**ZONING AMENDMENT,
PLANNED UNIT DEVELOPMENT &
SUBDIVISION STAFF REPORT**

Date: March 9, 2017

<u>NAME</u>	Ken Knuckles
<u>SUBDIVISION NAME</u>	Government and Dexter Subdivision, First Addition
<u>LOCATION</u>	1459 & 1465 Government Street (Southeast corner of Dexter Avenue and Government Street)
<u>CITY COUNCIL DISTRICT</u>	District 2
<u>PRESENT ZONING</u>	B-2, Neighborhood Business District and R-3, Multiple Family District
<u>PROPOSED ZONING</u>	B-2, Neighborhood Business District
<u>REASON FOR REZONING</u>	To allow commercial Planned Unit Development.
<u>AREA OF PROPERTY</u>	2 Lots / 0.4 ± Acres - Subdivision 2 Lots / 0.6 ± Acres - PUD 1 Lot / 0.2 ± Acres - Rezoning
<u>CONTEMPLATED USE</u>	<p>Subdivision approval to create 2 lots, Planned Unit Development Approval to allow shared access and parking between two building sites, and Rezoning from R-3, Multiple Family District, to B-2, Neighborhood Business District, to allow an ATM.</p> <p>It should be noted, however, that any use permitted in the proposed district would be allowed at this location if the zoning is changed. Furthermore, the Planning Commission may consider zoning classifications other than that sought by the appl

SITE PLAN

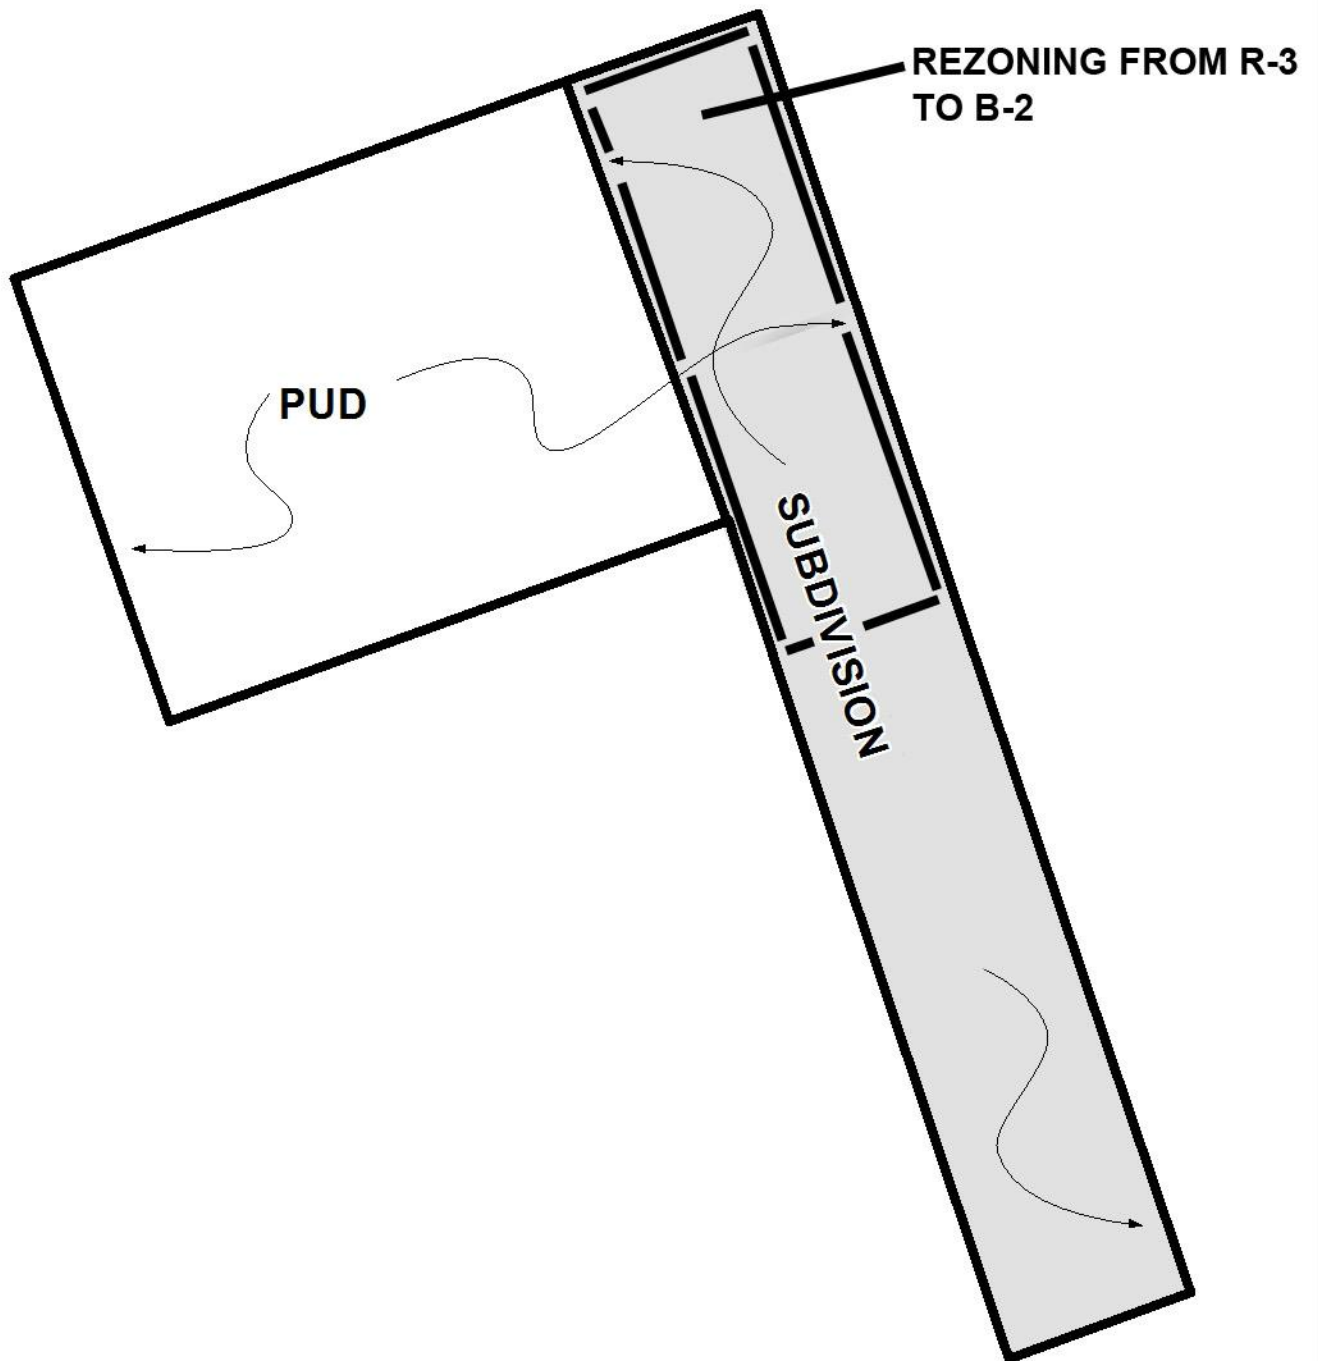
The PUD site plan shows that the proposed development will have one curb-cut to Dexter Avenue, and a second curb-cut, entrance only, from Government Street. The Government Street access includes a short deceleration lane that begins in front of the lot created in 2015, and which then clips the corner of the lot to provide access into the new lot that will be created as part of the Subdivision request being considered as part of this group application. The clipping of the 2015 lot may or may not be in compliance with the associated condition of approval denying access to/from Government Street.

Regarding the proposed development, the site plan shows that the drive-through for the proposed restaurant will be on the Government Street side of the proposed building, with the stacking lane within the front 25-foot setback, and the pick-up window facing Government Street. Visual inspection by staff of other restaurants on Government Street, from The Loop area to South Claiborne Street, show that no other restaurant has a drive-through on the Government Street frontage: all other restaurants and businesses (banks, drug stores) with drive-throughs have the facilities on the side facades of the buildings, thus not readily visible from Government Street.

The site also shows that the dumpster for the proposed restaurant will be placed on the adjacent lot that will be created as part of this application. The adjacent lot is additionally proposed to include a freestanding drive-up ATM.

While the proposed development will result in the closure of two driveways along Government Street, and the provision of a new neighborhood serving business - both in accordance with the intent of the Map for Mobile Traditional Corridor - the proposed deceleration lane will result in the removal of two existing live oak trees within the public right-of-way, and will create a very out of character situation of a drive-through directly fronting Government Street. Additionally, the proposed ATM will be out of character in terms of scale and use with other commercial uses along Government Street. The proposed curb-cut to Dexter Avenue will, it appears, also require the removal of one existing live oak within the public right-of-way. Thus, while access and circulation will be adequate for the proposed development, the relationship of the proposed commercial uses to the Government Street corridor, the historic district context of the site, and the proposed curb-cuts will adversely impact the historic nature of the corridor and the neighborhood.

Planned Unit Development: Based upon the preceding, the Planned Unit Development request is recommended for Denial for the following reasons:

- 1) The proposed deceleration lane will result in the removal of two existing live oak trees within the public right-of-way;
- 2) The proposed curb-cut to Dexter Avenue will result in the removal of one existing live oak tree within the public right-of-way;
- 3) The placement of a drive-through fronting the Government Street corridor will be out of character and with and negatively impact the historic character and nature of the corridor and neighborhood;
- 4) The proposed ATM will be out of character in terms of scale and use with other commercial uses along Government Street; and
- 5) The development proposed for the site would not generally support the intent of the Traditional Corridor designation assigned via the Map for Mobile process.
